SEQUOIA

OUTLINE OF NEW FEATURES

The following changes have been made for the new Sequoia.

Models with Rear View Monitor 11YBE301S

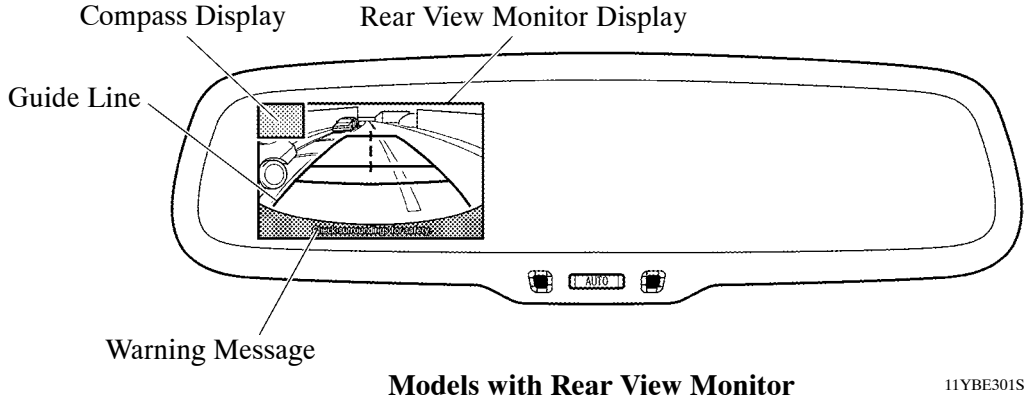
9. Inner Rear View Mirror

- Following items have been changed on models with the rear view monitor in order to improve convenience.
  - The rear view monitor display size has been increased to 3.3 inches and a warning message and guide lines have been added to the display.
  - The compass display has been changed from the Liquid Crystal Display (LCD) type to a Thin Film Transistor (TFT) type.
- The compass display on models without the rear view monitor has been changed from the Vacuum Fluorescent Display (VFD) type to a Thin Film Transistor (TFT) type.
